Access Compliance Report

Public Rights-of-Way

(Curb Ramps)

Intersection ID: 49458	Main Street: PEBBLE_RUN_DR	Cross Street: TILLEY_MORRIS_RD	Location: SE
ADA ID: 0B97268CE08B	Ramp Type: BlendTrans1	Initial Pass/Fail: Fail	Overall Compliance: No
Severity Score: 8.75			
Codes/Mitigation Info/Possible Solution		Field Measurements/Component Compliance

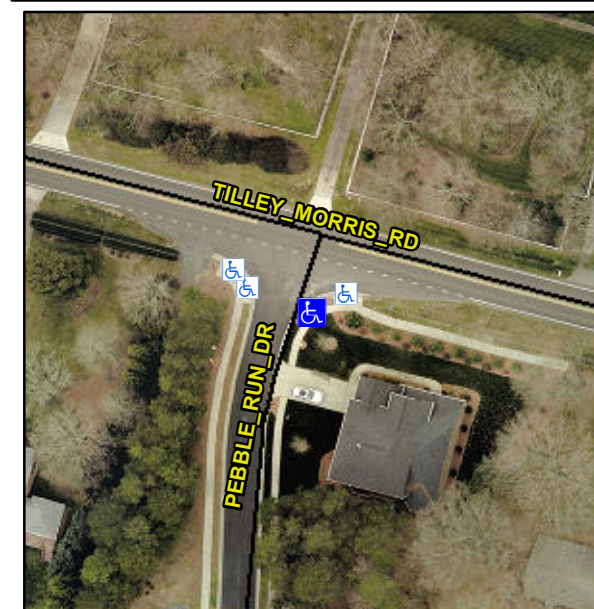
Not Found, R304.5.1

Compliance	Description	Data	Compliance	Description	Data
N/A	Ramp Length (in)	48.0	Yes	BlendTrans Slope (%)	3.4
No	Ramp Width (in)	47.5	Yes	BlendTrans XSlope (%)	1.6
N/A	Flare Type LT	N/A	N/A	Flare Type RT	N/A
N/A	Flare Slope LT (%)	N/A	N/A	Flare Slope RT (%)	N/A
N/A	Flare Traversable LT?	N/A	N/A	Flare Traversable RT?	N/A
N/A	Landing Length (in)	N/A	N/A	DWS Provided?	N/A
N/A	Landing Width (in)	N/A	N/A	DWS Contrast?	N/A
N/A	Landing Slope (%)	N/A	N/A	DWS Length (in)	N/A
N/A	Landing X Slope (%)	N/A	N/A	DWS Full Width?	N/A
N/A	Landing Curb? (Y/N)	N/A	N/A	DWS Offset (in)	N/A
N/A	Shared Landing?	N/A			
N/A	Gutter Ponding?	N/A	N/A	Gutter Slope (%)	N/A
N/A	Gutter Lip Ht (in)	N/A	N/A	Gutter X Slope (%)	N/A
N/A	Painted X Walk1?	No	N/A	Painted X Walk2?	N/A
	X Walk 1 Direction	To W		X Walk 2 Direction	N/A
	X Walk 1 Width (in)	N/A		X Walk 2 Width (in)	N/A
	X Walk 1 Slope (%)	1.2		X Walk 2 Slope (%)	N/A
	X Walk 1 X Slope (%)	1.0		X Walk 2 X Slope (%)	N/A

N/A	Ramp inside XWalk1?	N/A	N/A	Ramp inside XWalk2?	N/A
	Road Slope (%)	1.0		Clear Space?	N/A
	Road X Slope (%)	1.2	N/A	Clear Space to XWalk (in)	N/A
N/A	Any Obstructions?	N/A	N/A	Storm Grate/Utility Hazard?	N/A
	Obstruction Type			Storm Grate/Utility Type	
		N/A			N/A
			Yes	Surface Condition? (G/P)	Good
			No	Curb Slope (%)	13.9

Remove & Replace Curb Ramp With Two New Directional Ramps or Equivalent.
